FINAL DRAINAGE PLAN AND REPORT

MURR SUBDIVISION

PCD File: MS231

Revised
August 8, 2023

DEVELOPED CONDITIONS
DRAINAGE BASIN SUMMARY

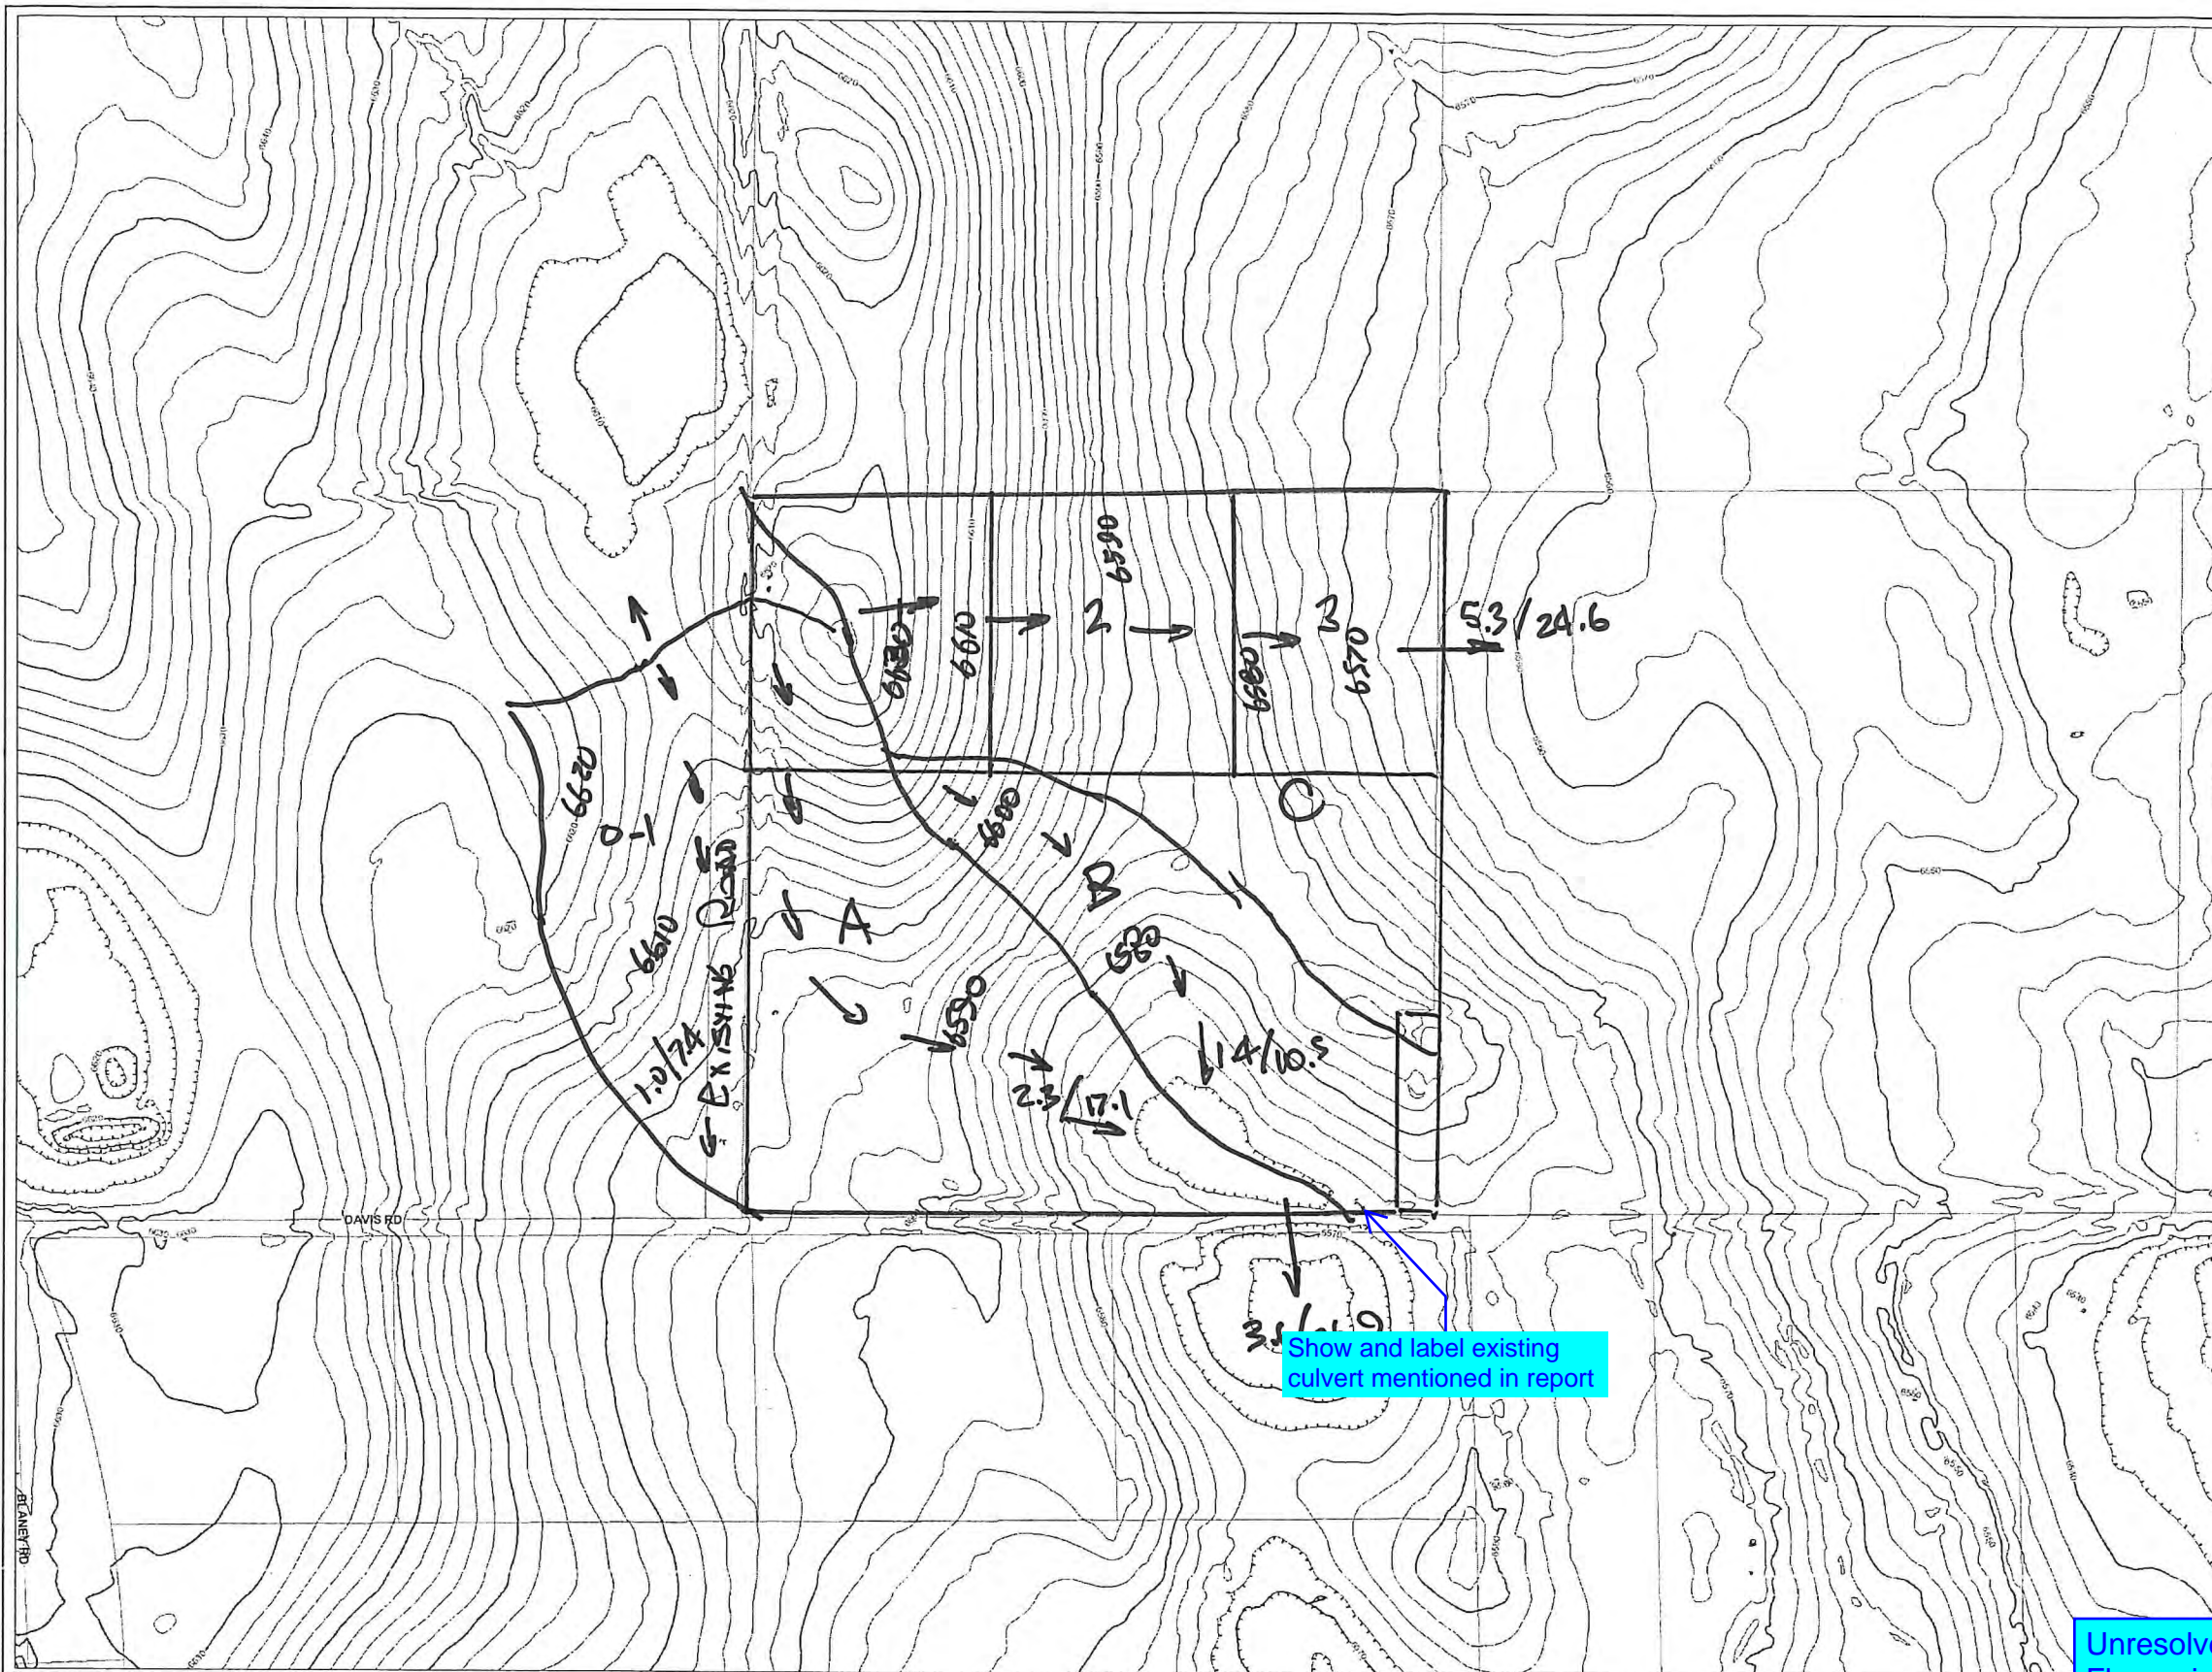
Unresolved from Review 2:
Flows significantly increase after
development. Per unresolved
comment on page 7, address
whether detention is required
because of runoff increase.
